Ausgrid Revenue Proposal 2019-24

**Review of aspects of Ausgrid's
forecast capital expenditure**

Australian Energy Regulator

Energy Market Consulting associates

Figure 5: Annualised actual/forecast capex versus annualised allowance for previous, current and next RCP (\$m, real June 2019)

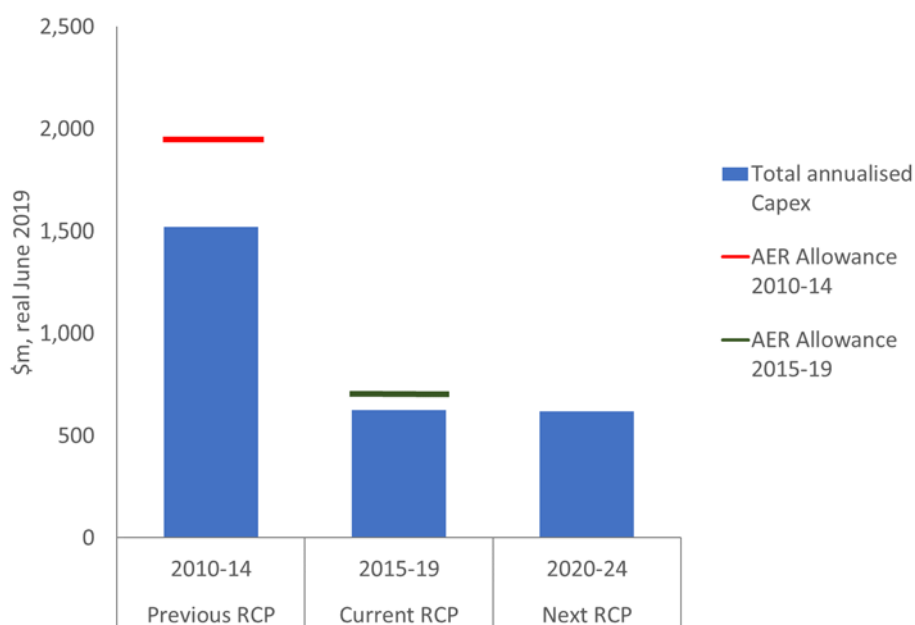
47. The figure below shows that Ausgrid has underspent its capex allowance in both the current and previous RCPs, indicating a possible over forecasting bias.

Figure 14: Ausgrid's proposed repex – difference from the Repex model

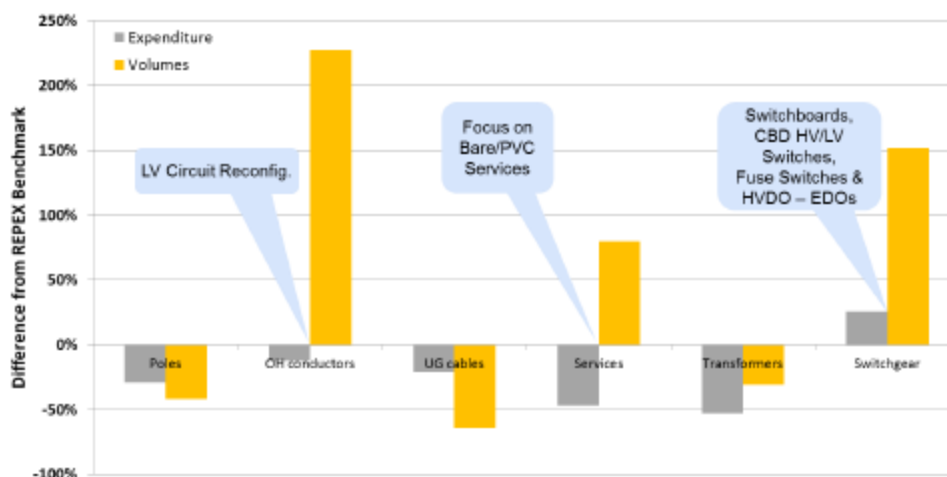
175. Ausgrid has compared its proposed repex by category, with category-level outputs from its modelling using the AER's Repex model. The results of its analysis are shown in the figure below.

Figure 20: Environmental risk reduction ranking of oil filled cables

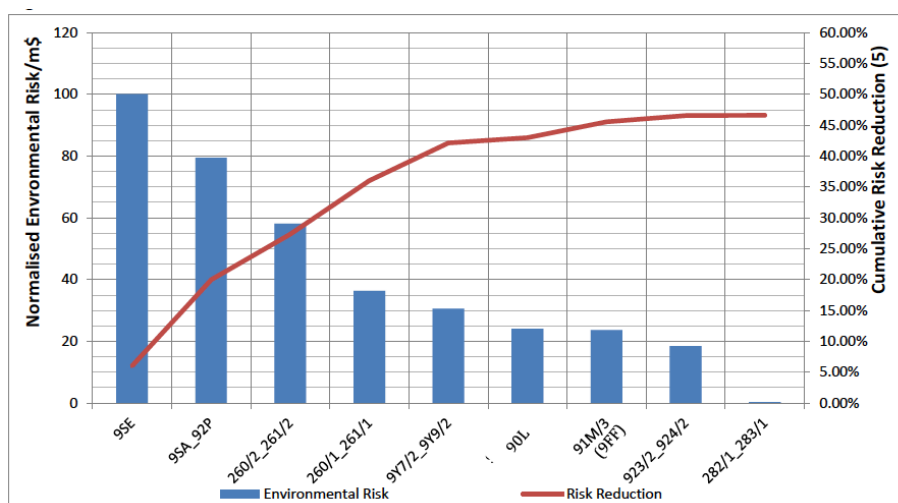
291. We have not been able to reconcile the environmental risk reduction developed from the environmental risk model with the cables identified for replacement in the next RCP, specifically the information from the following sources:
- list of projects identified in Figure 11 of Attachment 5.14.2 (as reproduced above) – which denotes 9 projects, with the highest environmental risk reduction contribution being cable 9SE;
 - list of projects included in Table 2 of Attachment 5.14.2 that Ausgrid has planned for replacement and decommission in the next RCP – which lists 12 projects, of which 8 are replacement projects, with the highest environmental risk reduction contribution being 9SA & 92P;

Figure 21: Beaconsfield to Zetland CBA Risk Cost assessment

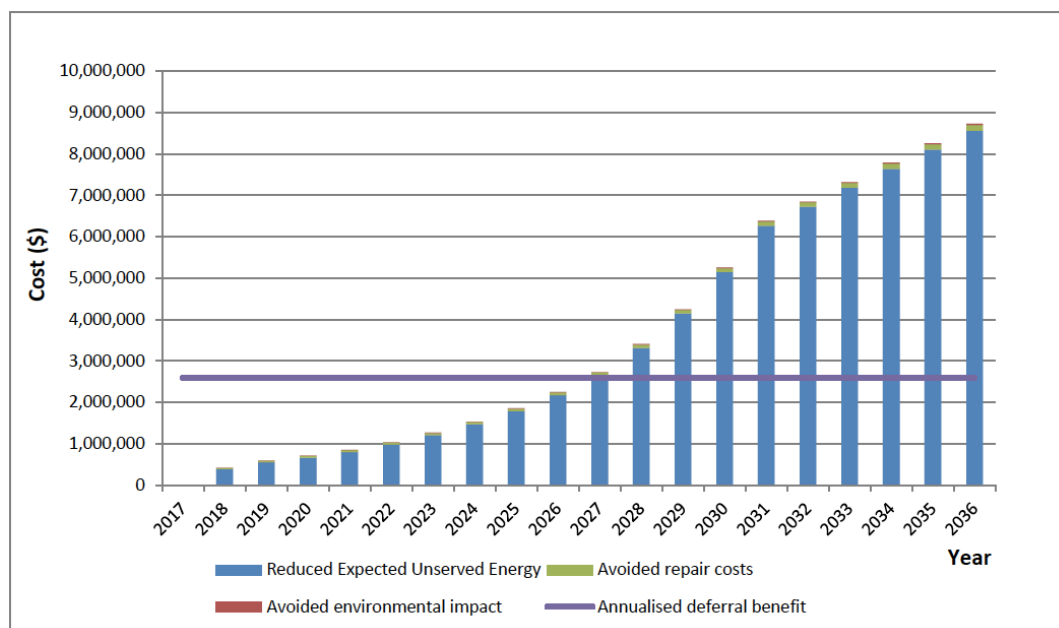
highly¹⁵¹ on Ausgrid's calculation of environmental risk reduction contributions as shown below. Because of its relatively high ranking on environmental risk, Ausgrid's plan is to advance the commencement of the project to fall within the next RCP.

297. The timing for the project, and therefore the expenditure in the next RCP, is dependent on the application of Ausgrid's *Environmental Management Strategy*.¹⁵² Despite these feeders ranking highly on the environmental risk reduction priority, the risk cost analysis in the CBA of this project (see figure below) does not indicate a high avoided environmental impact cost. This suggests to us that the environmental risk ranking is not formed on an economic basis. Notwithstanding Ausgrid's commitment to the EPA, Ausgrid's assessment does not unequivocally lead to a conclusion that it is prudent to undertake the project in the next RCP.

Figure 28: Fleet & Plant capex for the previous, current and next RCP (\$m, real June 2019)

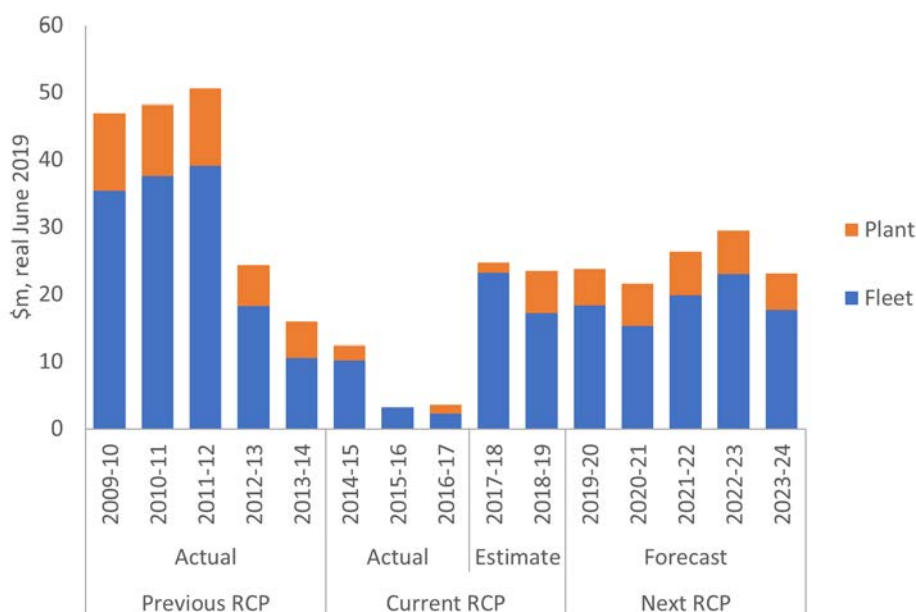
⁴⁷⁶. Ausgrid has forecast Fleet and Plant capex of \$124.3m for the next RCP compared to actual/estimated capex in the current RCP of \$67.2m, representing an increase of 84.7% (or \$56.9m).
